October 19, 2021

RE: Site Plan Review-Peer Review
#1355 Main Street Energy Storage System (ESS)
ZP Battery Devco, LLC
Map 26/Parcel A1

Hannigan Engineering is in receipt of comments from Quinn Engineering, Inc. regarding the project submitted by this office for a Solar Energy Storage System (ESS) in Leicester, Massachusetts. We have reviewed the comments and offer our responses below. We have left the same format of their letter for ease of review. These responses have been incorporated into the updated plans for final review and approval by the Board.

LOCUS PLAN IN LEICESTER, MASSACHUSETTS

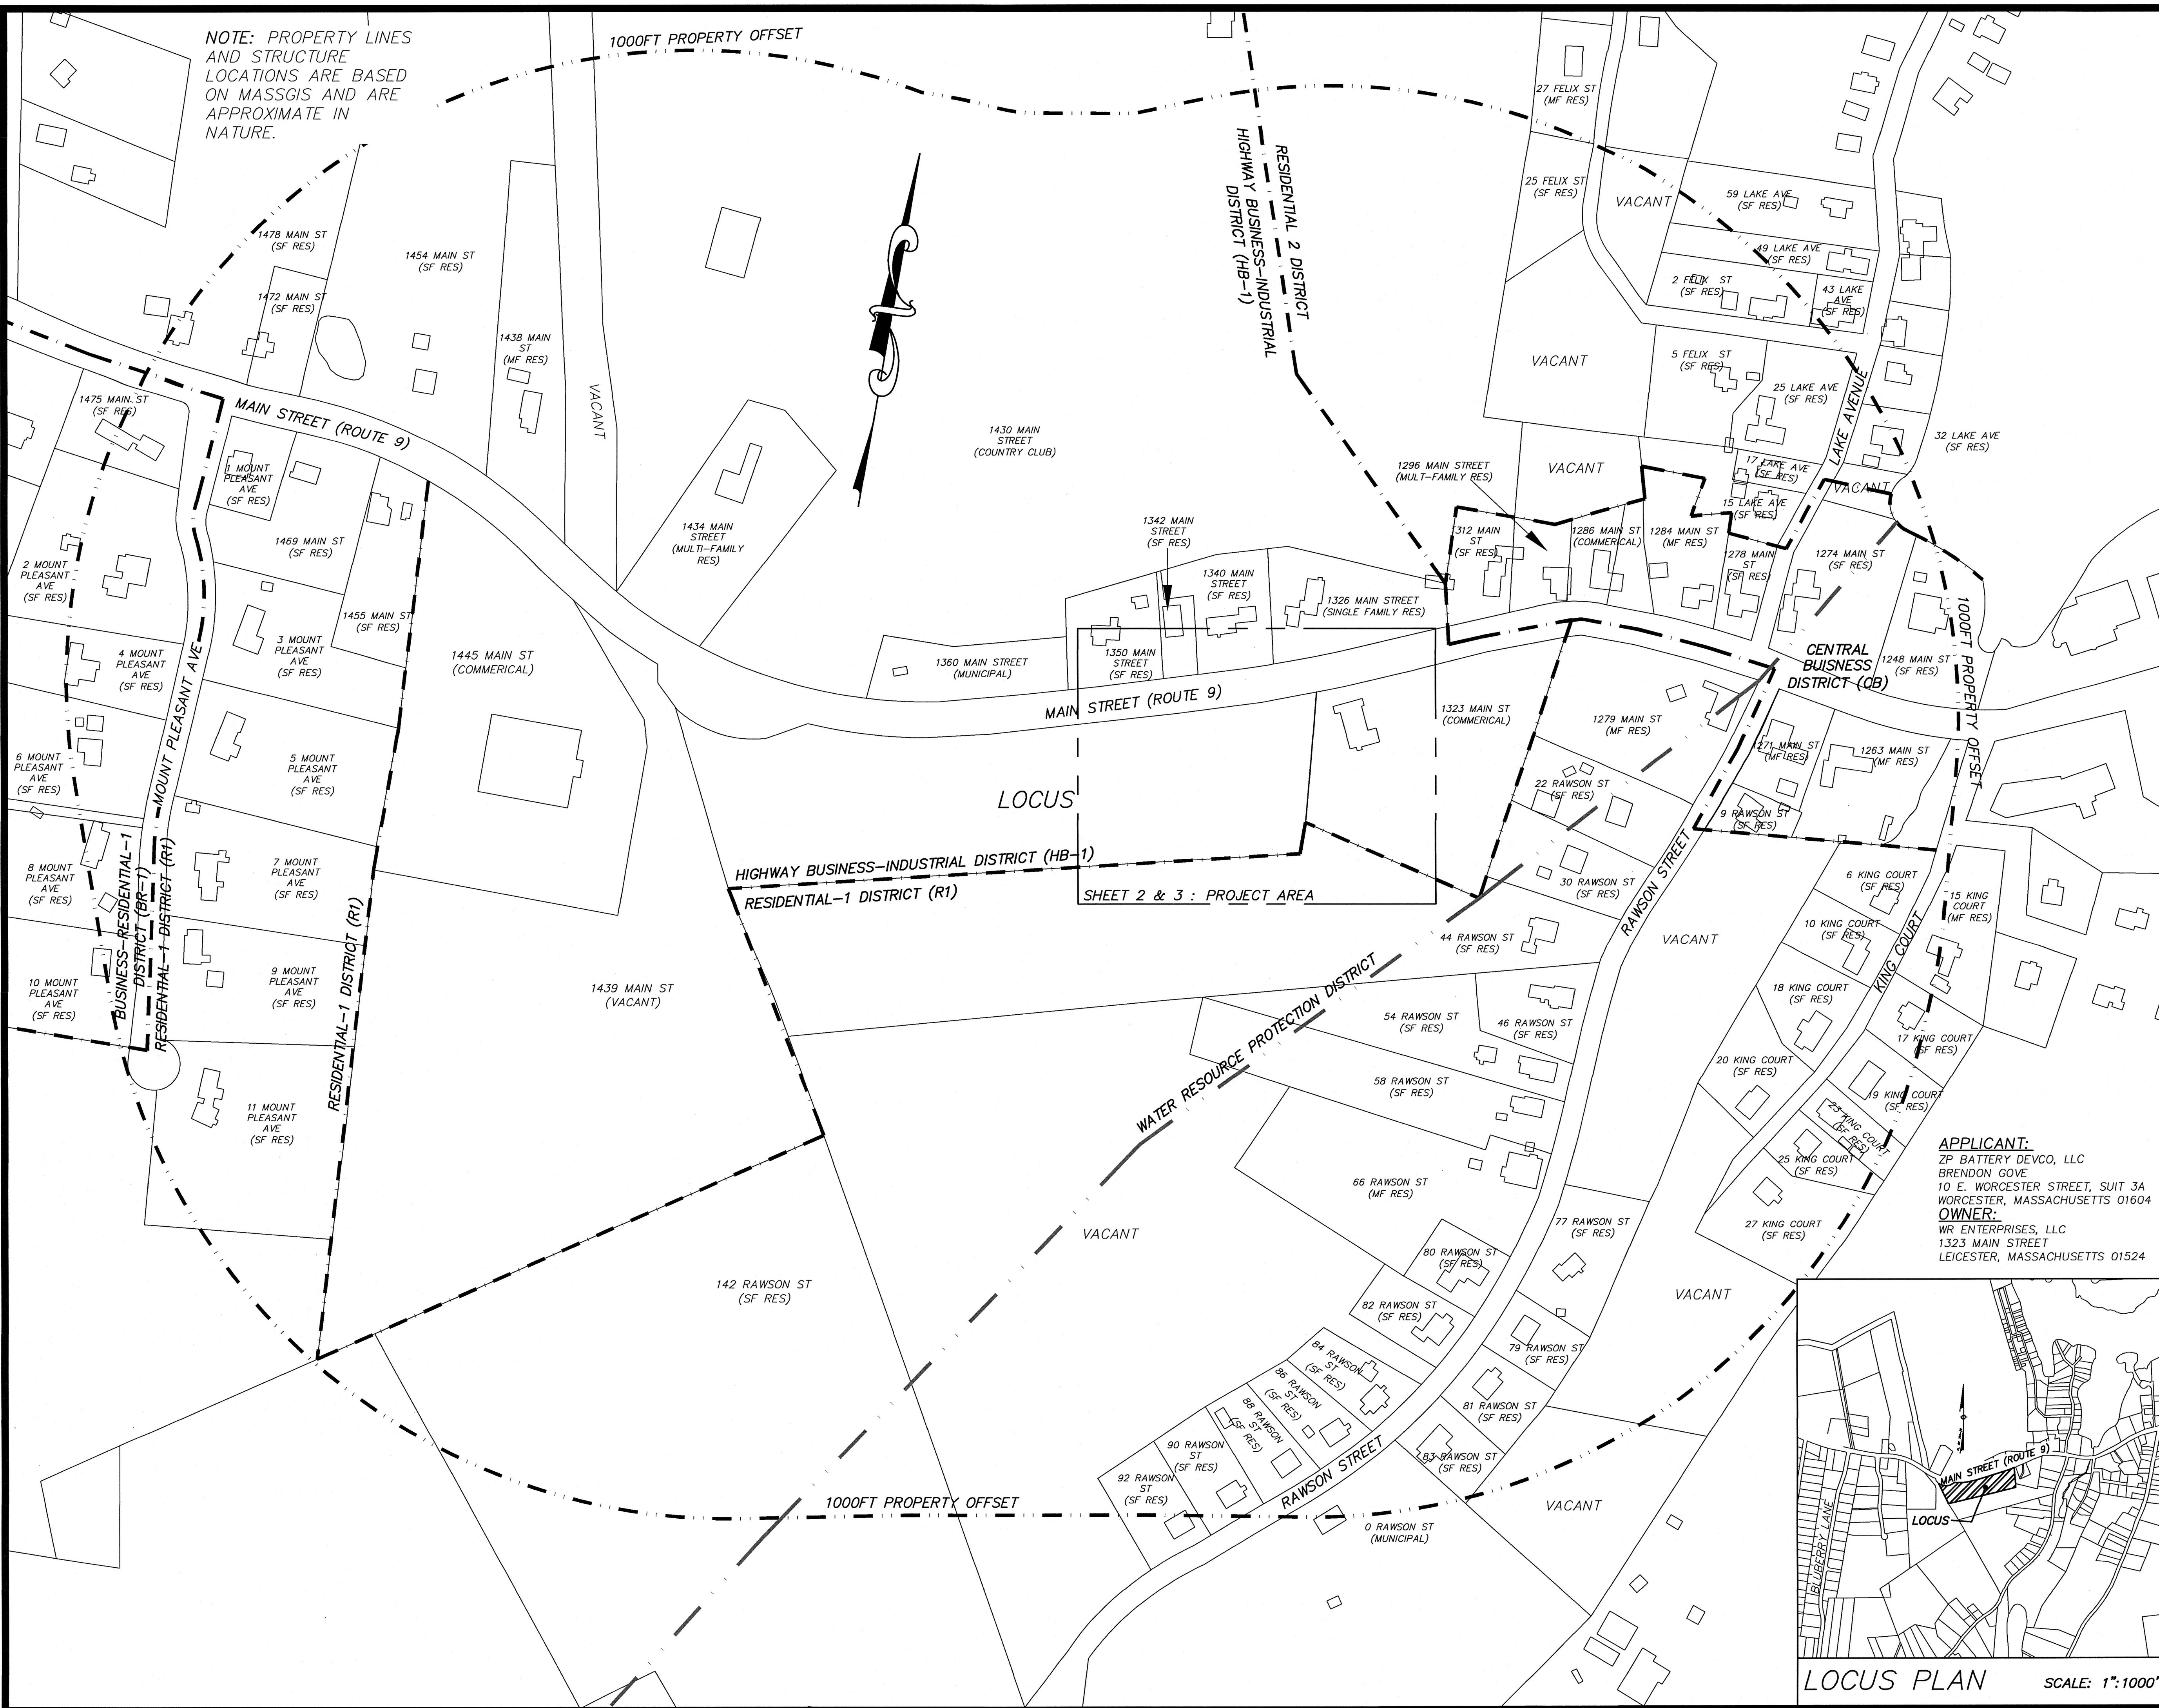
Comment #5: The locus plan provided does not meet some of the requirements specified in SPRR II.G.

Response: A Locus Plan has been incorporated into the revised Plan Set.

CALC: CMA	DRWN: CMA	SCALE: 1"=20'
CHKD: WDH	APPD: WDH	DATE: SEP 21, 2021
SRV: JEF	FB: 71-22	JOB NO: 3010
TAB: (4) SDP	SHEET 4 OF 6	PLAN NO: C-17-38

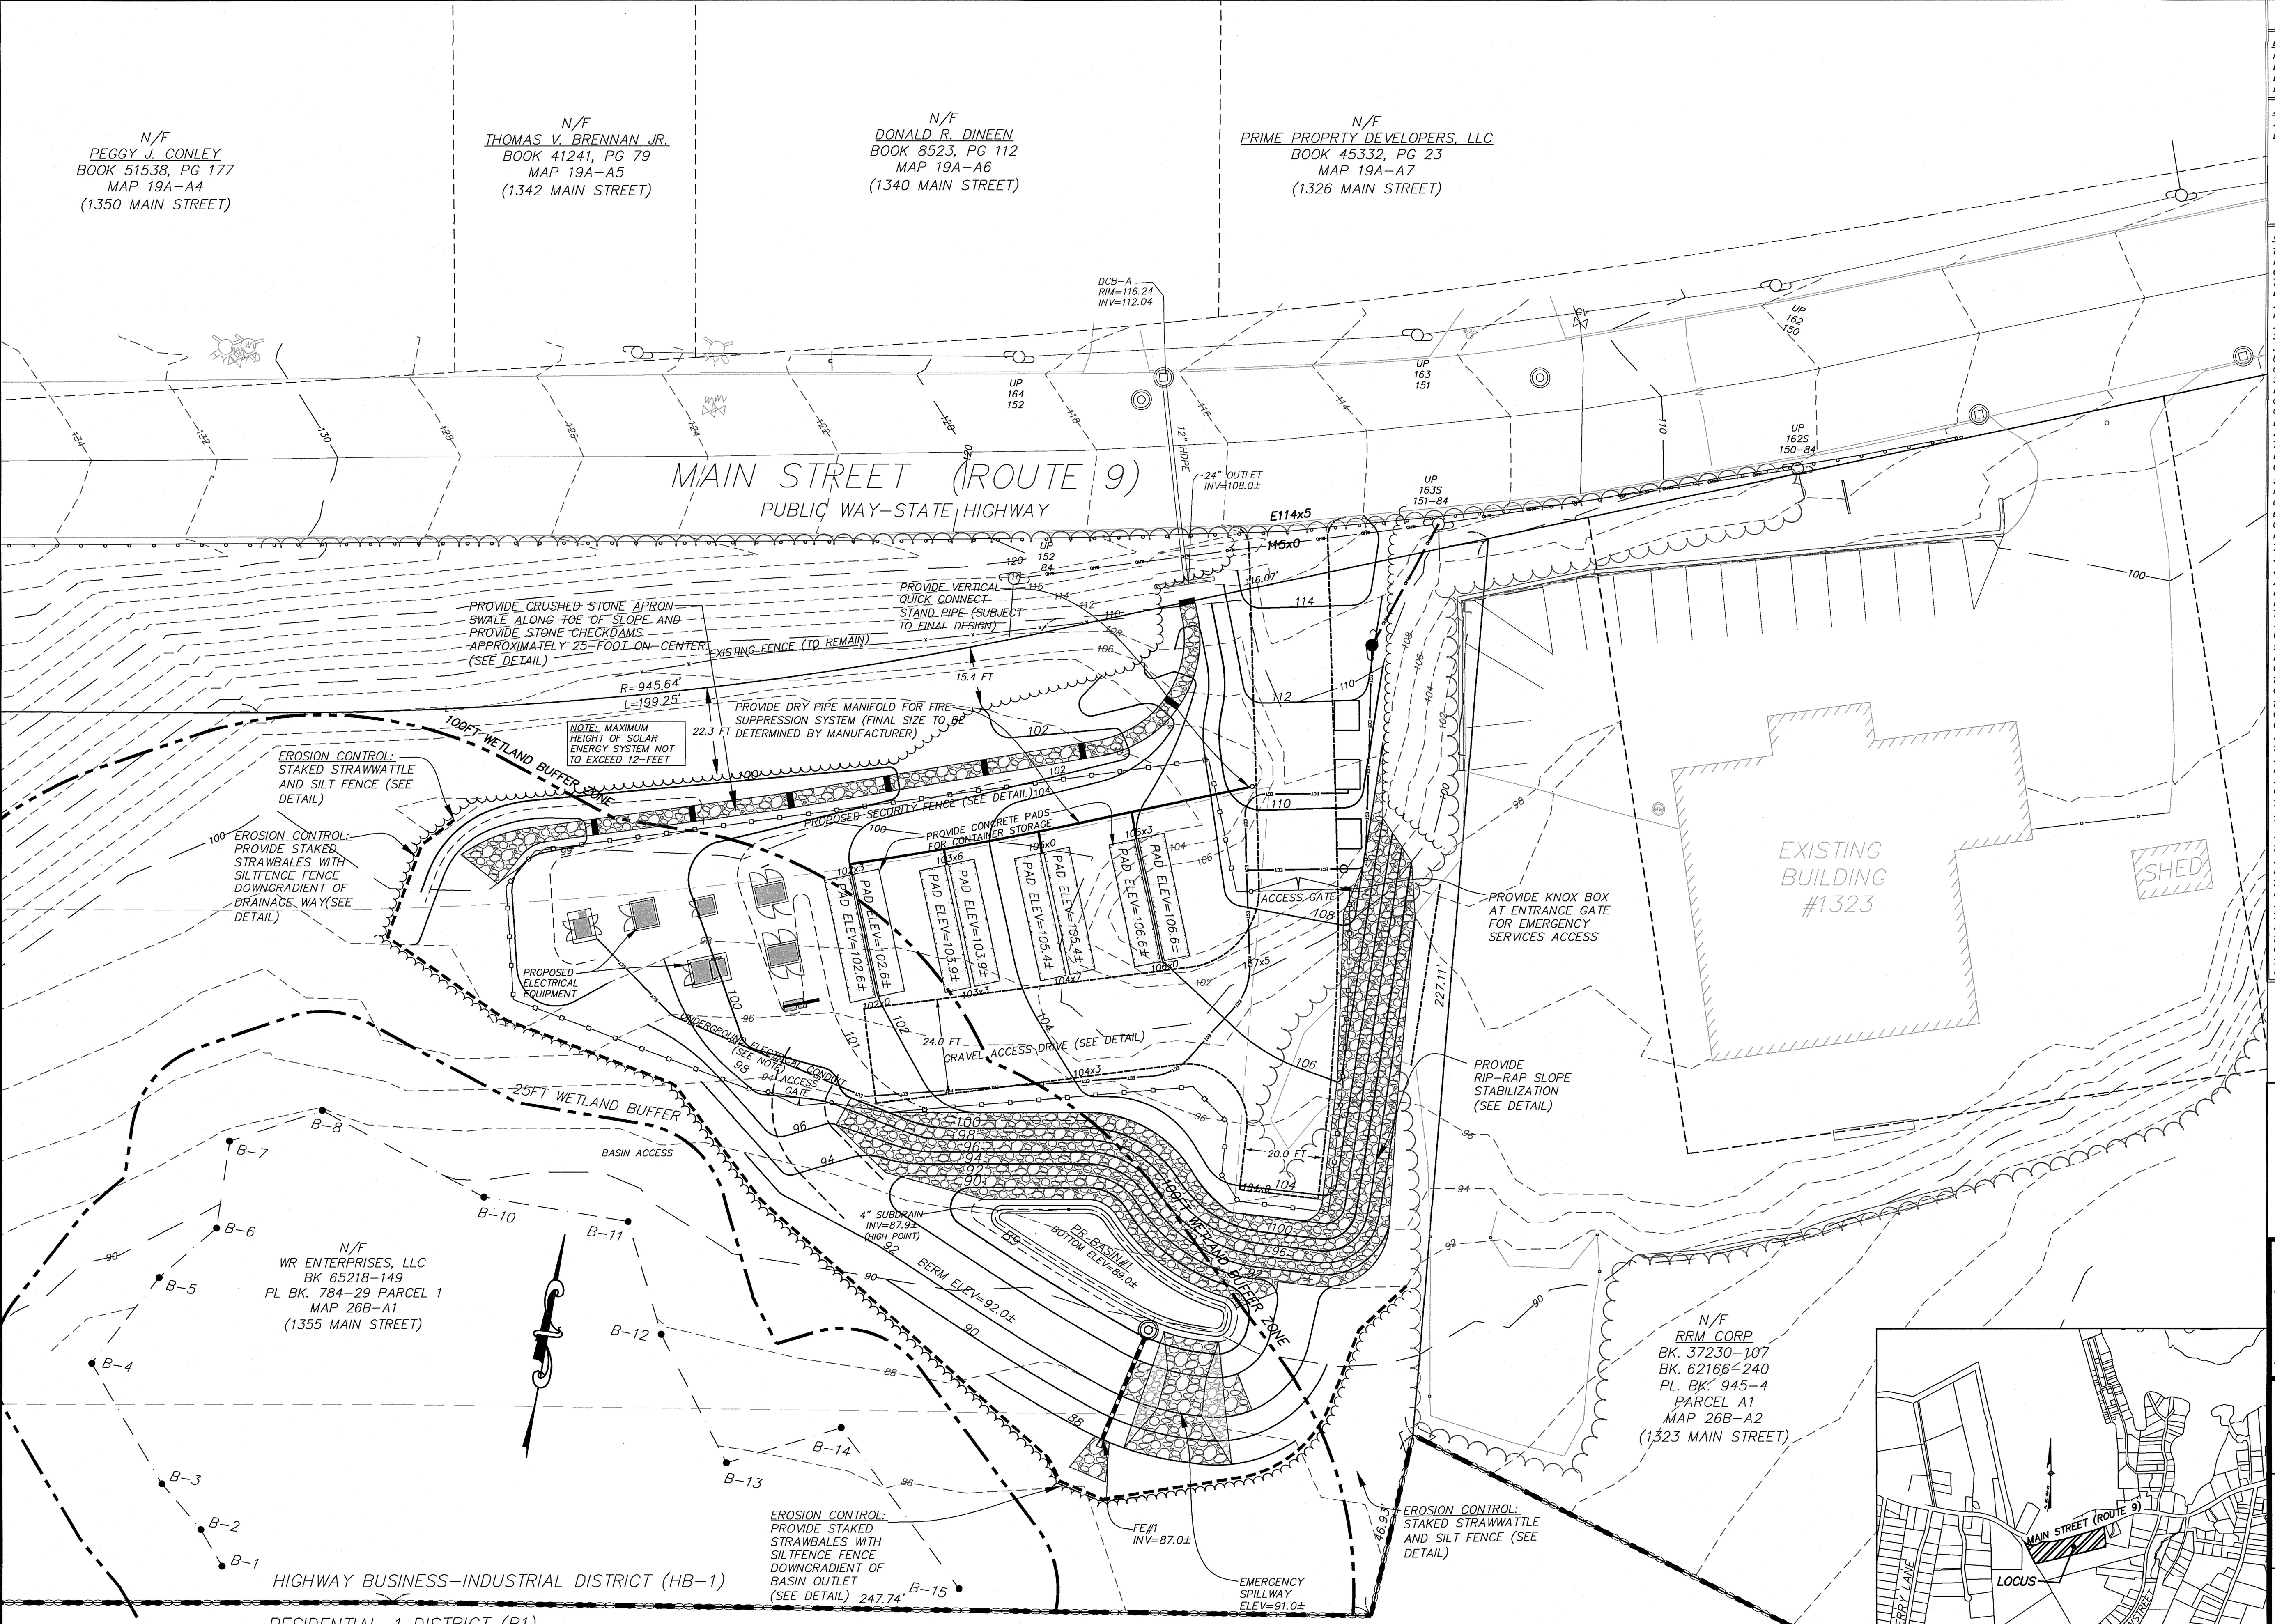
Comment #11: Based on the proposed grading, it appears that runoff from the easterly equipment pads may not flow to the basin as intended. The grading should be revised to ensure that the intended runoff reaches the basin.

Comment #13: The extent of the rip rap slope stabilization called out on Sheet 3 must be depicted on plan.

Comment #14: Runoff from the driveway has potential to erode the slope between the driveway and basin. Additional stabilization is recommended on this slope.

Comment #15: Check dams are recommended along the flow path of the existing discharge from the catch basin in Main Street to minimize erosion potential along the toe of the proposed slopes.

Response: The proposed grading has been revised to direct additional runoff towards the detention basin.

Response: The extent of the rip-rap stabilization has been depicted on the Site Plan.

Response: Additional Rip-rap has been provided for between the detention basin and driveway.

Response: Check dams and a stone swale have been provided downstream of the existing discharge and along the toe of the proposed slope to prevent erosion issues.

1.5:1 RIP RAP SLOPE DETAIL
NO SCALE

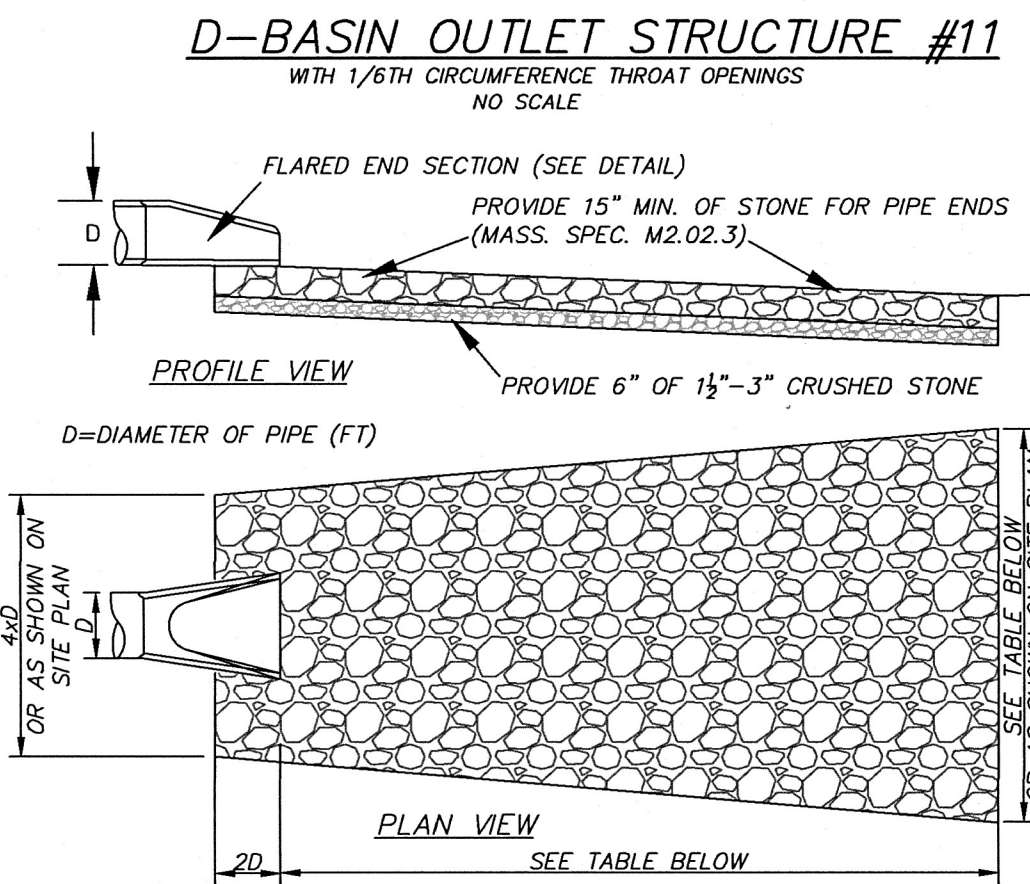
Comment #12: A rip rap slope stabilizing detail is referred to on Sheet 3, however, the detail was not found in the plan set. The detail should be provided.

Response: A rip-rap slope detail has been added to the Plan.
